ADDENDUM NO. 02

**High School Addition & Renovation
Jr. High Addition & Renovation
Intermediate School Controls Renovations
Primary School Controls Renovations
Softball Concessions
Ellettsville, IN 47429**

ADDENDUM NO. TWO

**Richland-Bean Blossom CSC
Additions and Renovations**

SITE
LANDSCAPE
PLAN

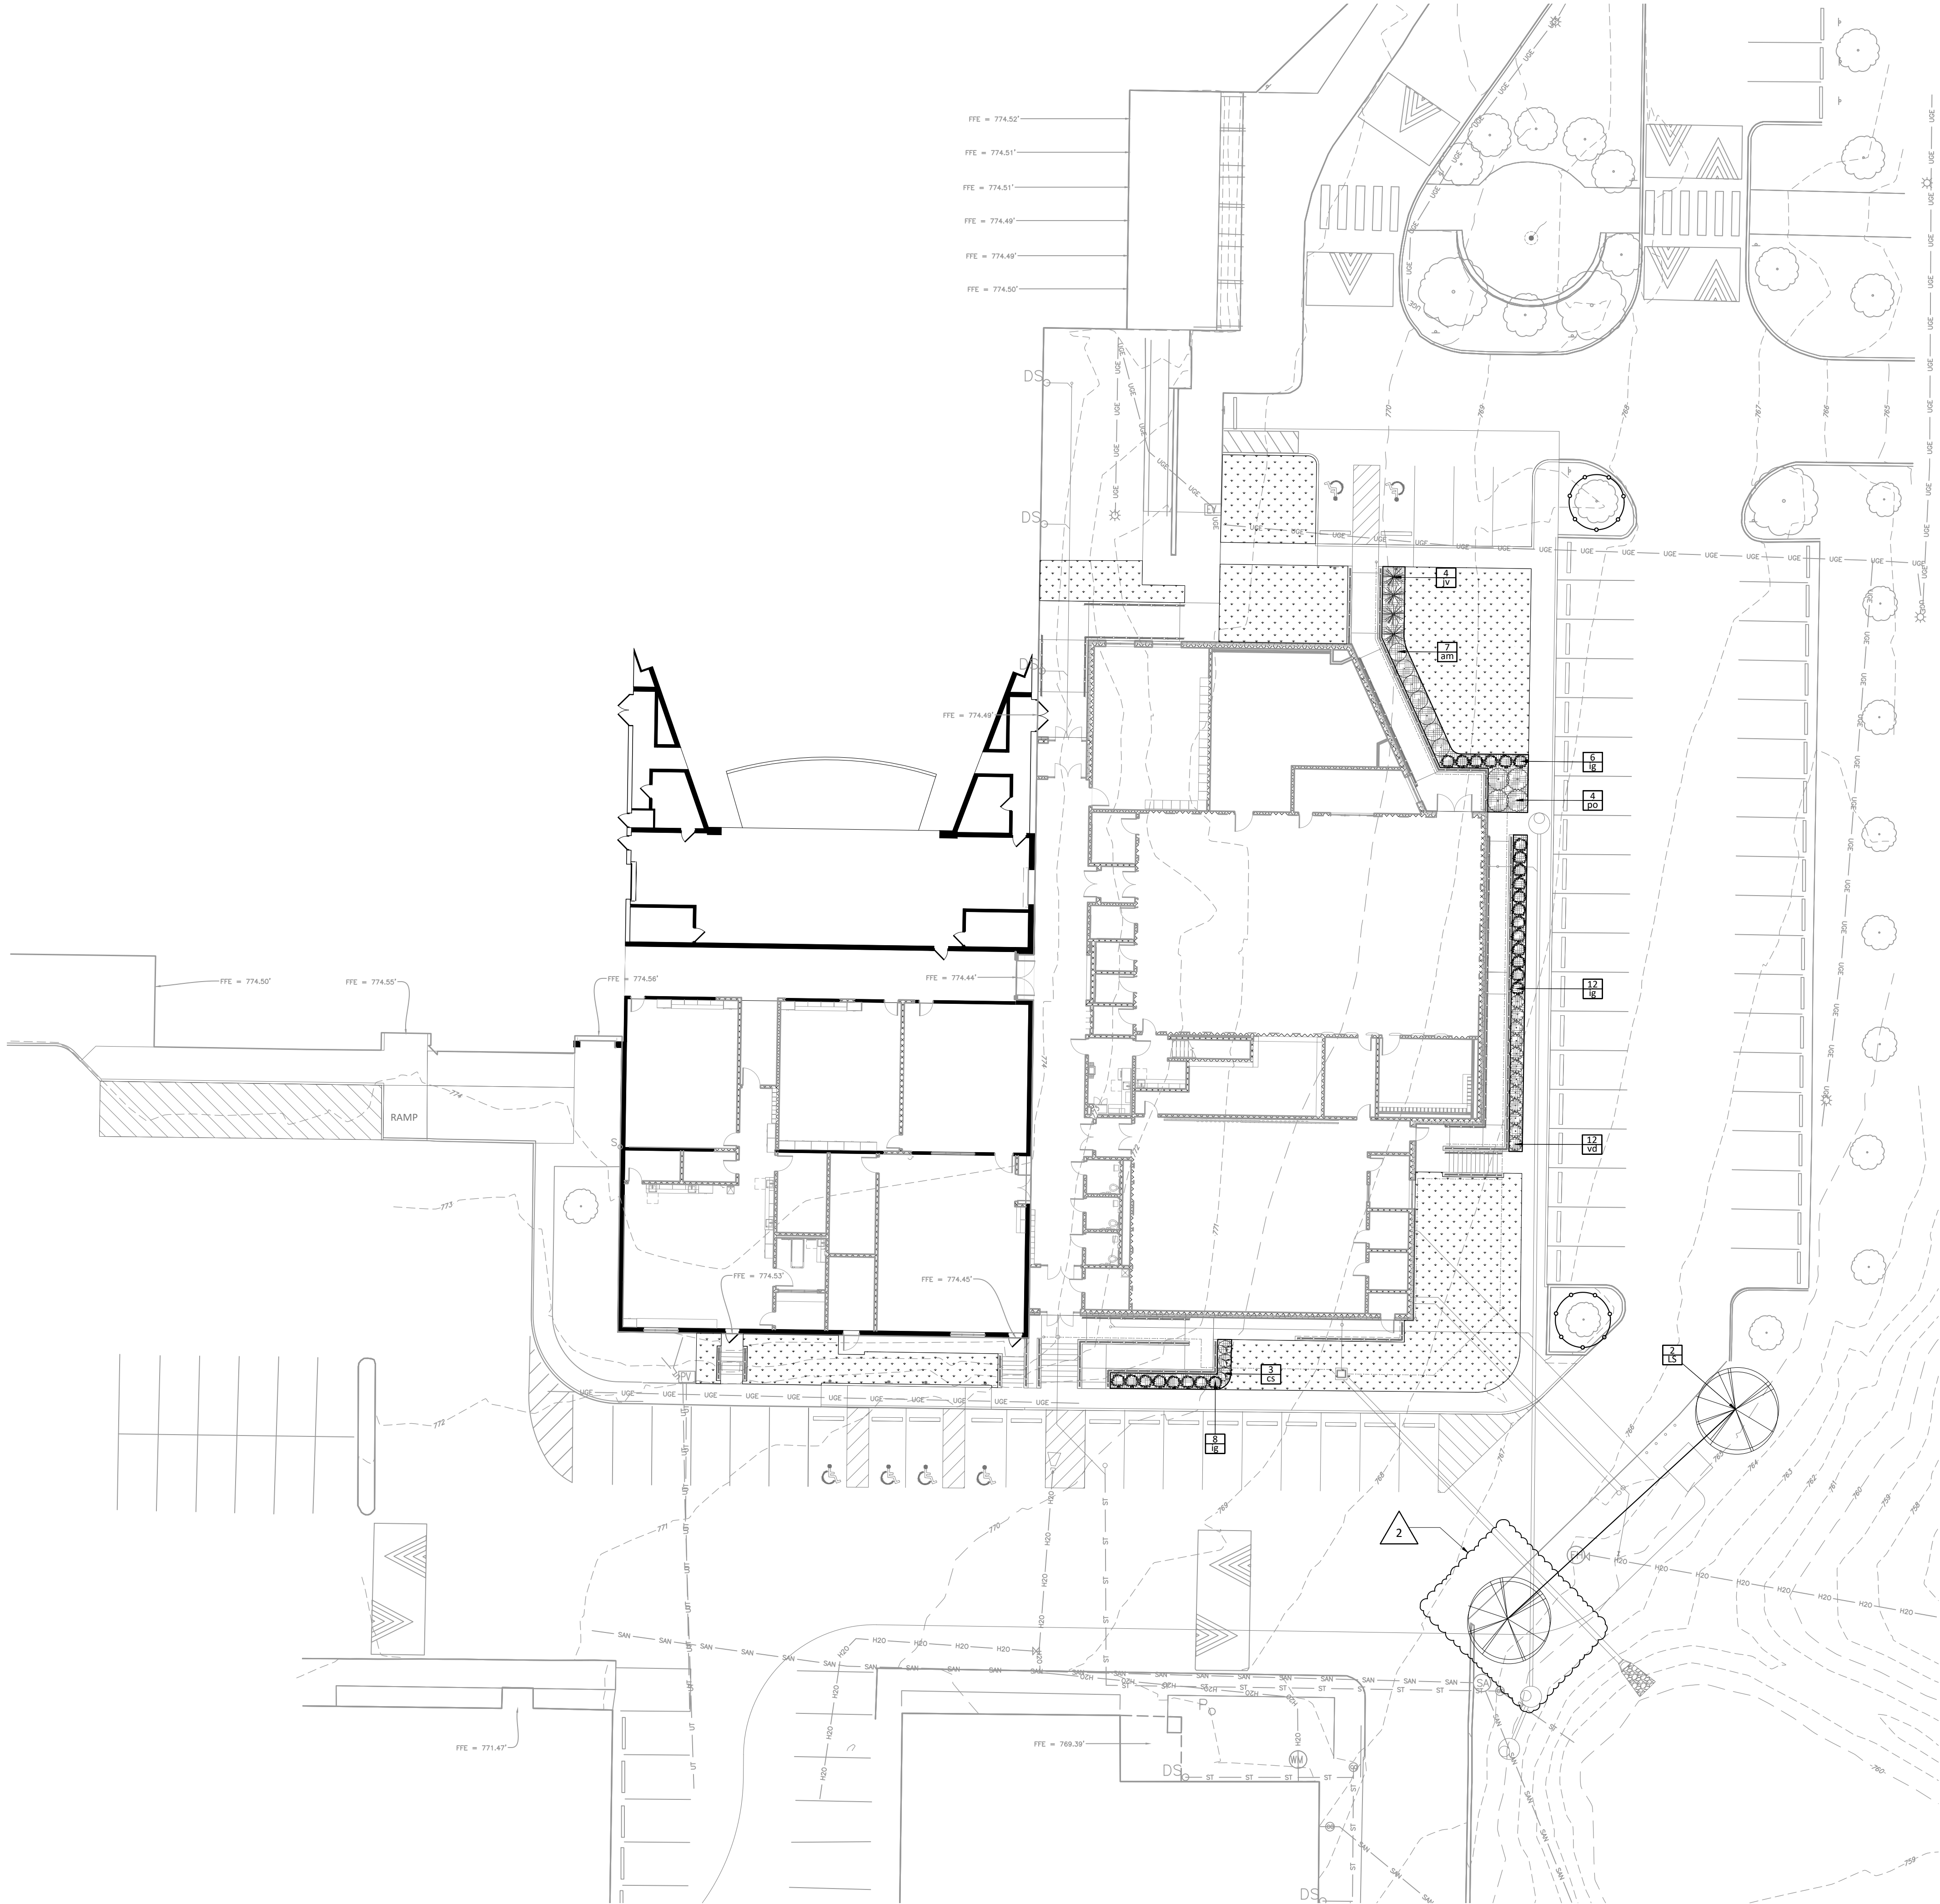
- a) Revised tree location to accommodate sanitary revisions.
6. C501 – Site Grading Plan – Remove and replace with attached.
 - a) Revised grading for detention basin.

SITE UTILITIES PLAN

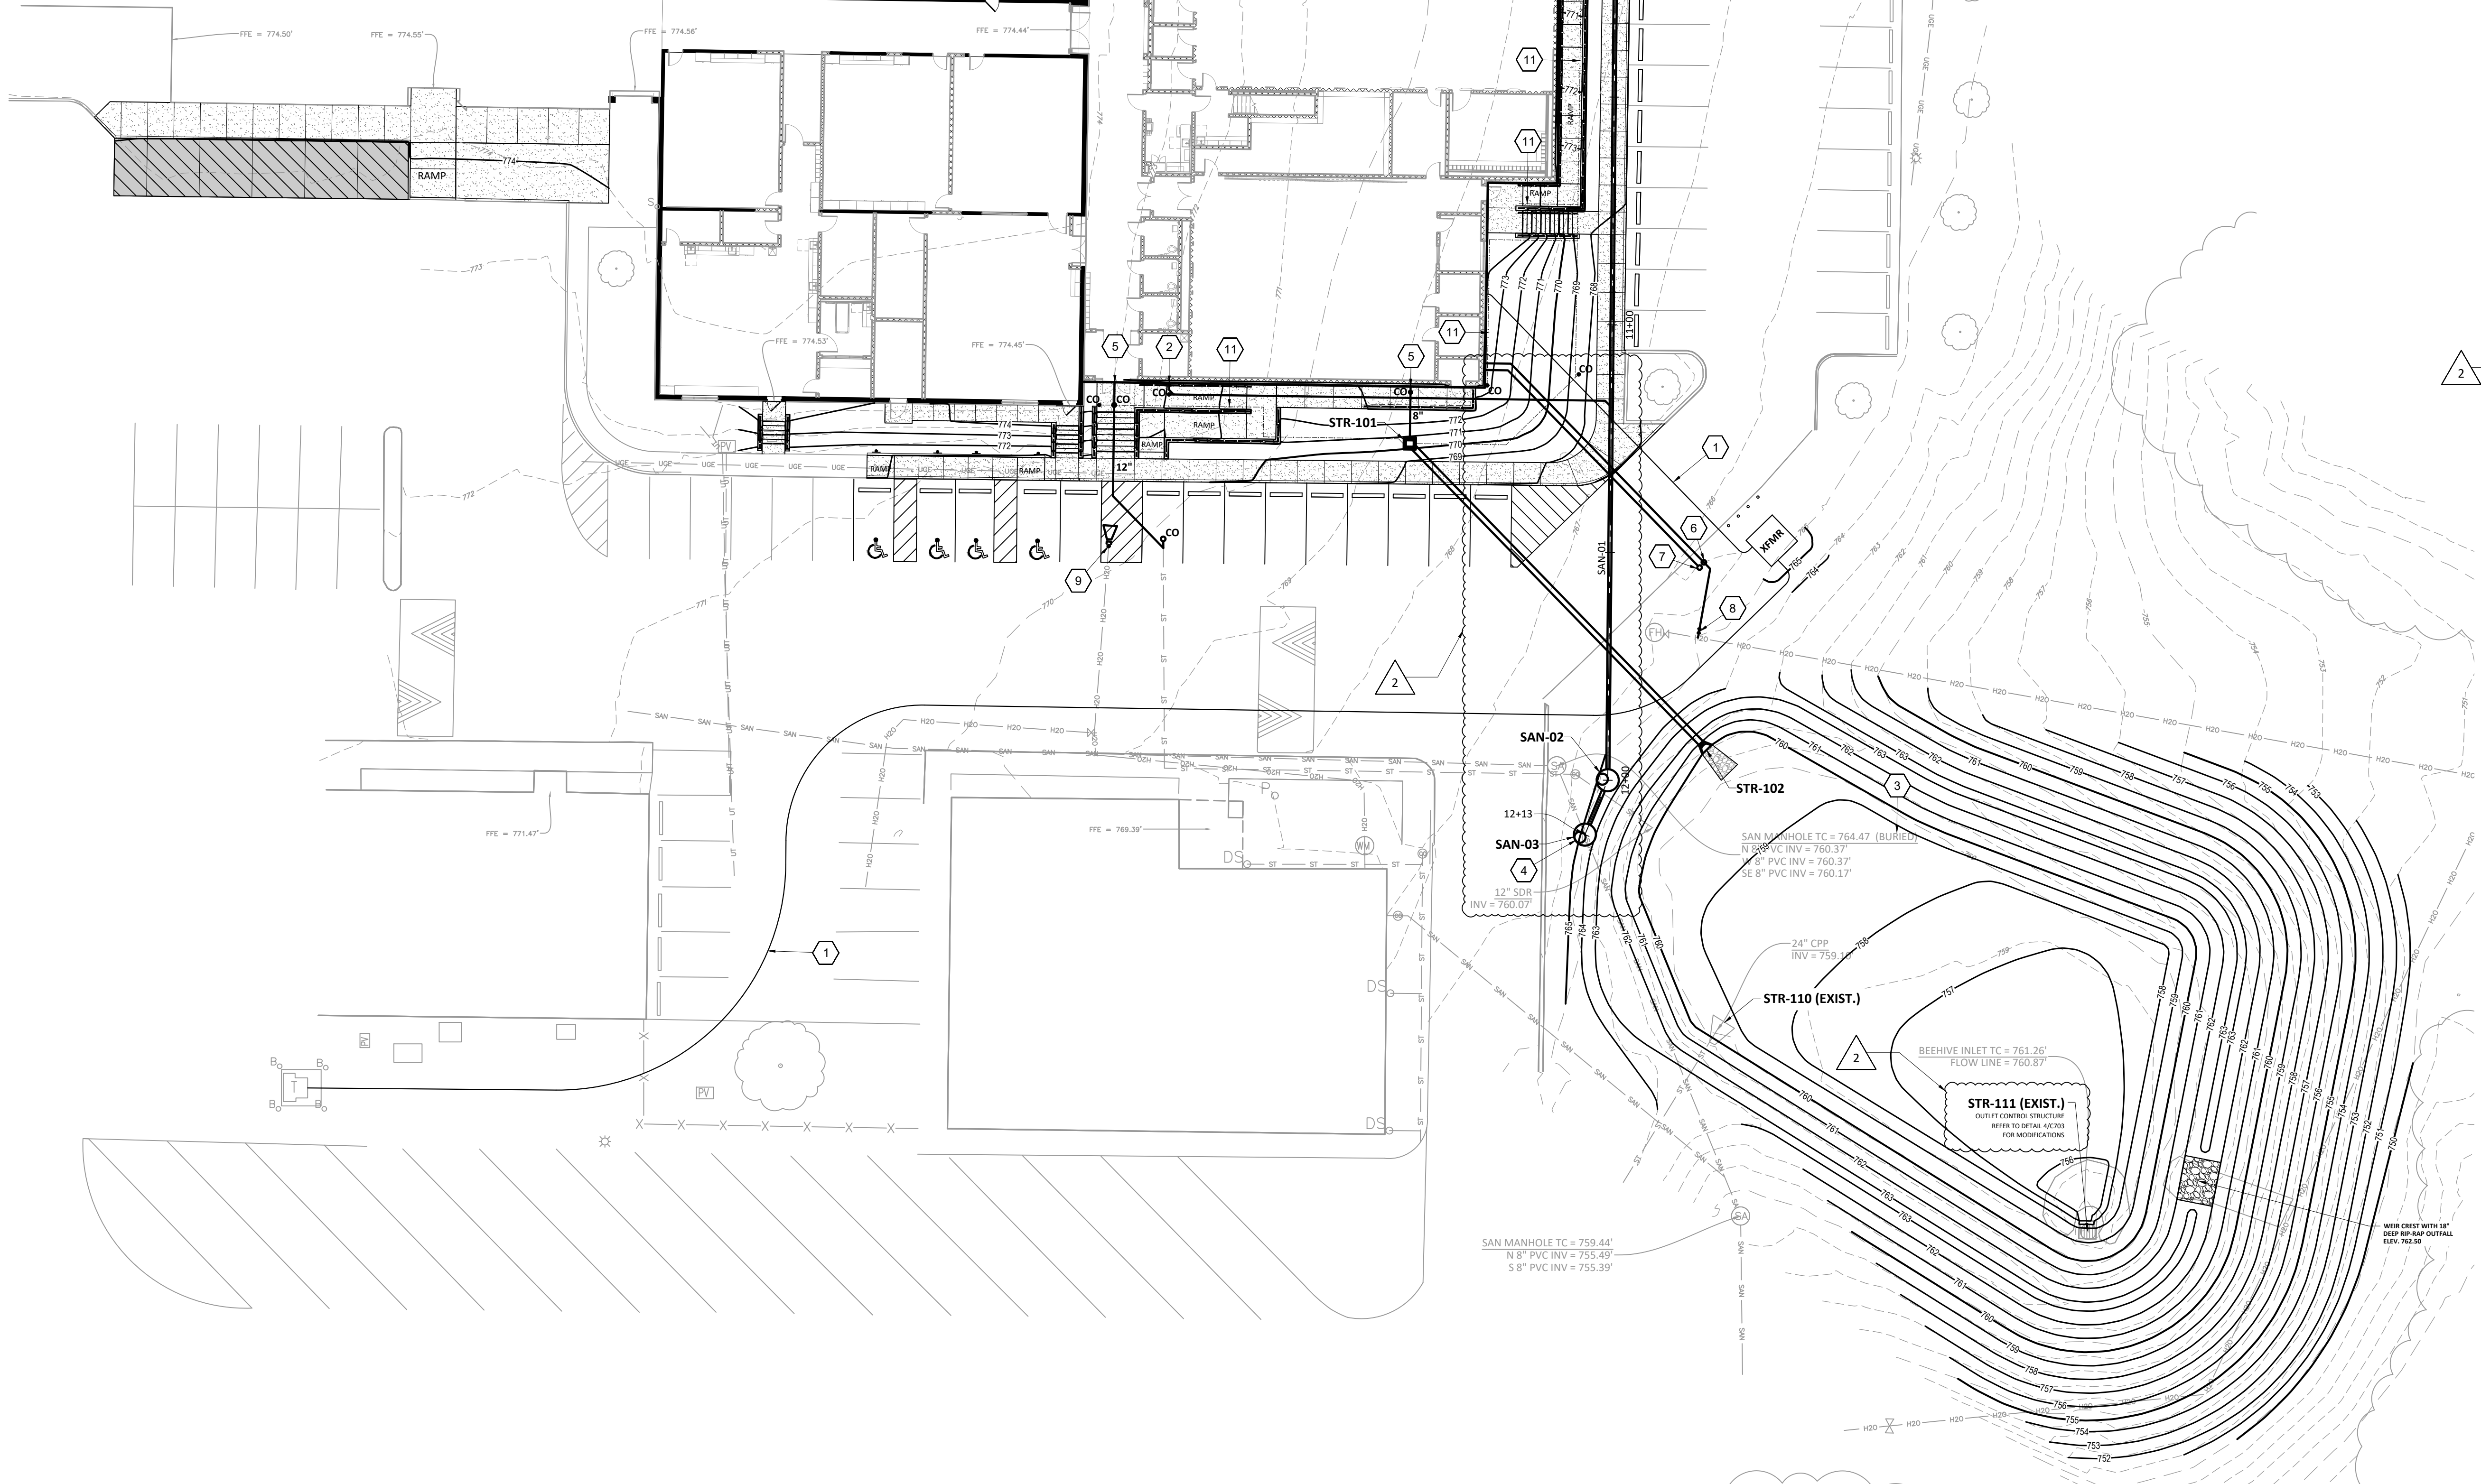
7. C601 – Site Utilities Plan – Remove and replace with attached.
 - a) Revised note for outlet control structure.
 - b) Revised sanitary main alignment and elevations.

- c) Updated sanitary structure data table.
 - d) Revised sanitary sewer profile SAN-01.
 - e) Revised Plan Note 4.
8. C703 – Site Details – Remove and replace with attached.

9 BEAM/LINTEL BEARING PLATE DETAILS

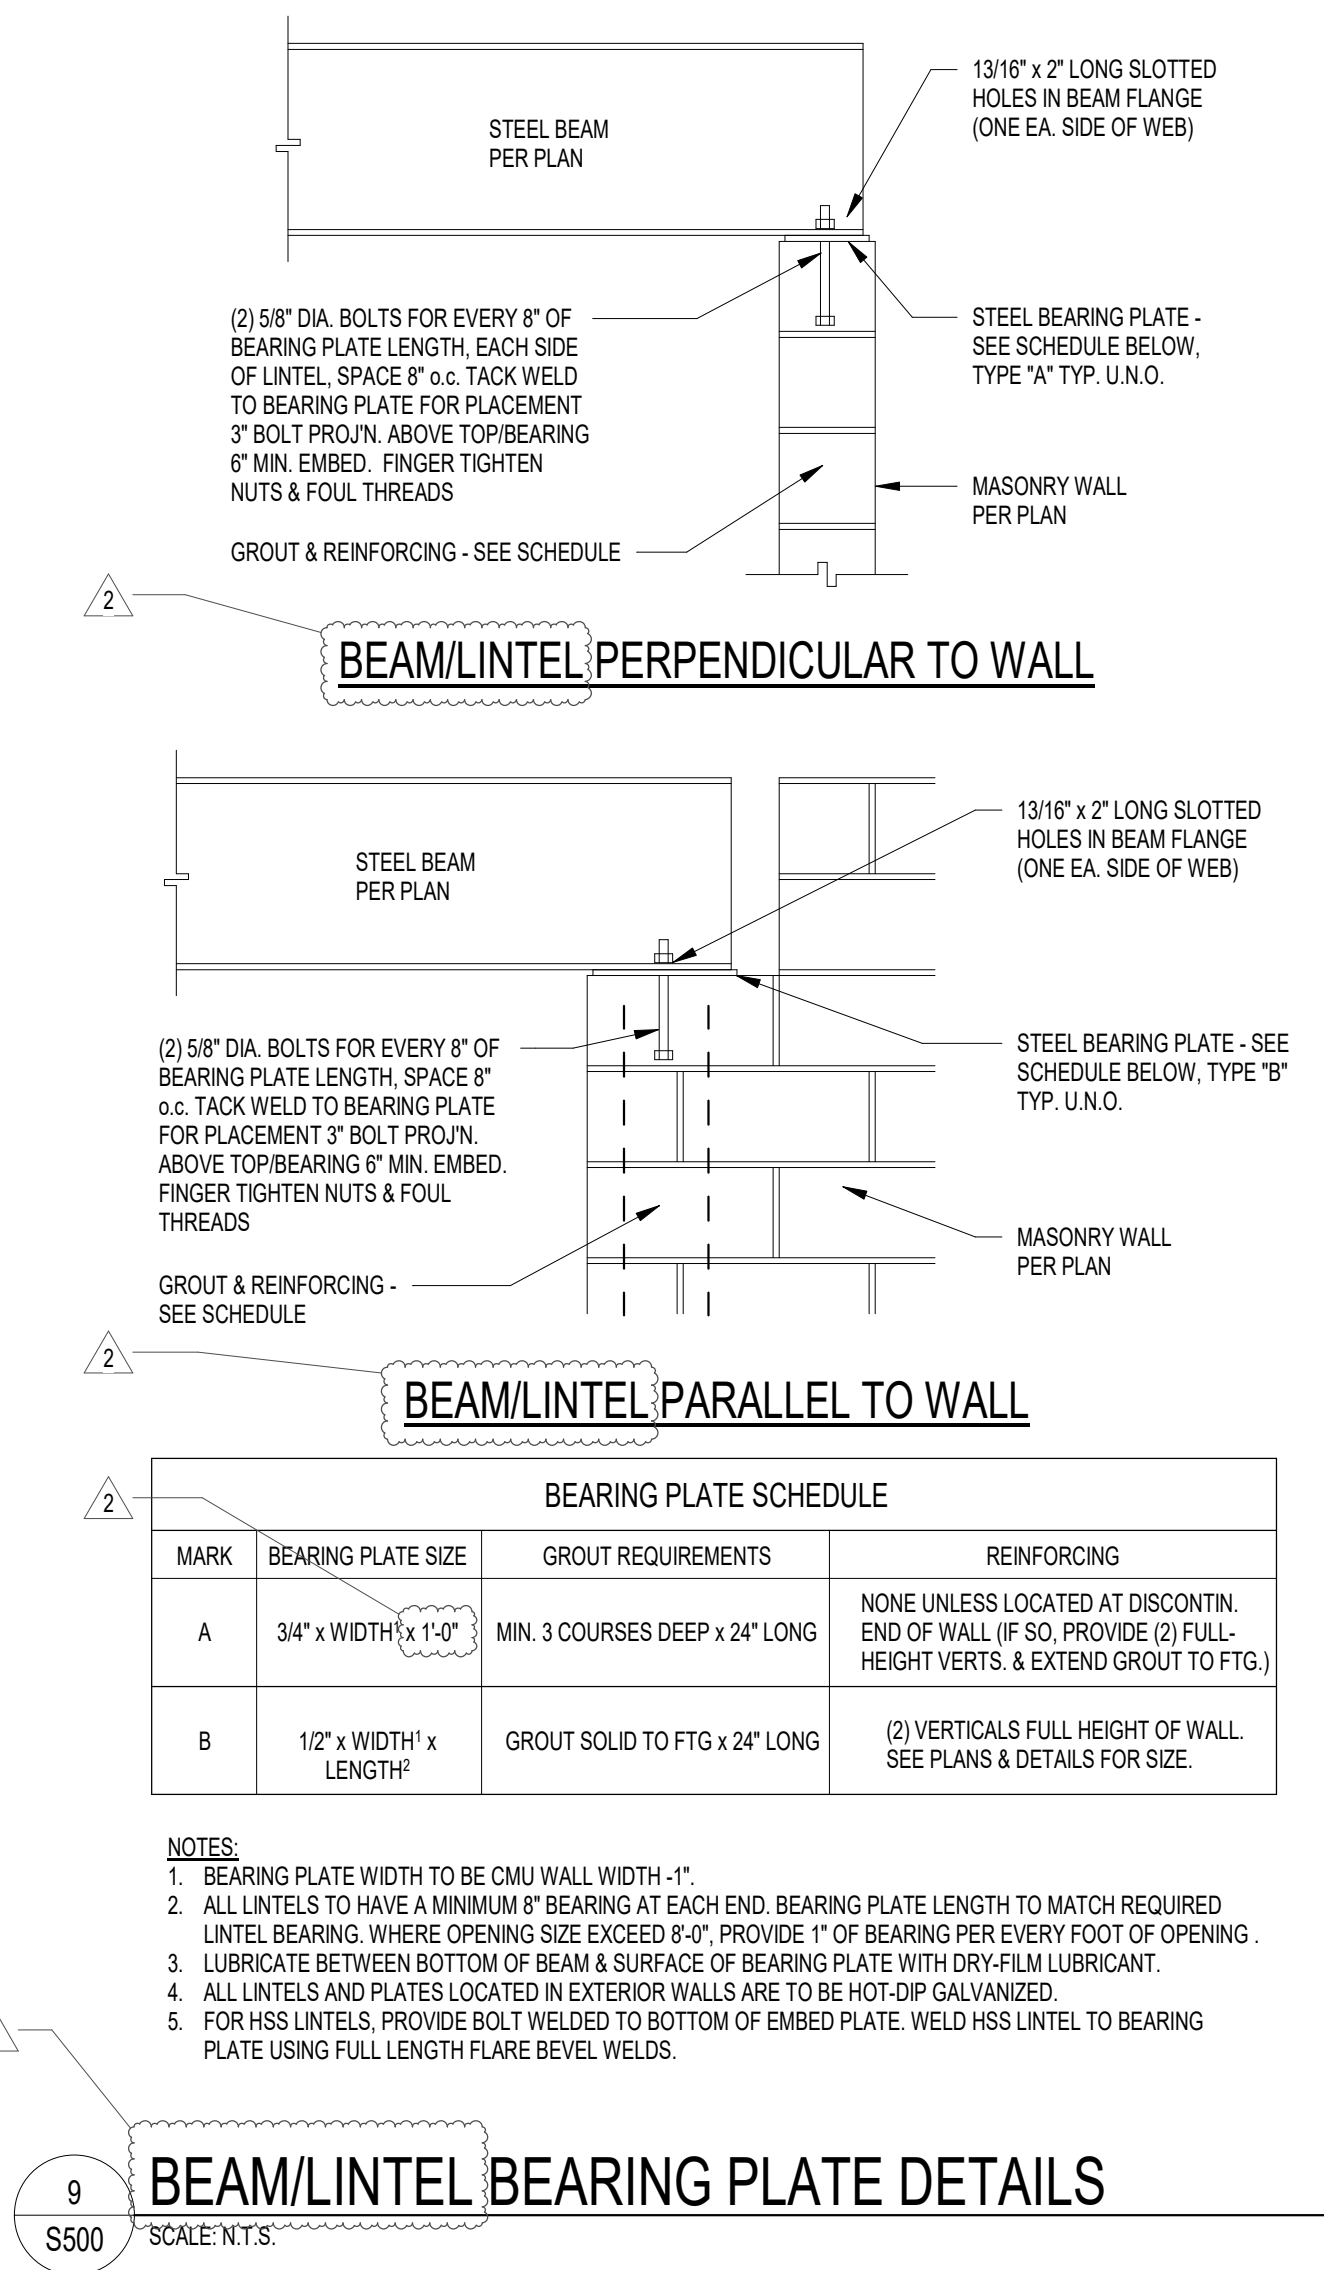
- a) Added Details 4 and 5 for the basin modifications.
9. S500 – TYPICAL MASONRY DETAILS
 - a) Updated title of 'Beam Bearing Plate Details' (Detail 9) to include lintels. Reduced the required length of bearing plates for beams/lintels bearing on perpendicular CMU bearing walls.
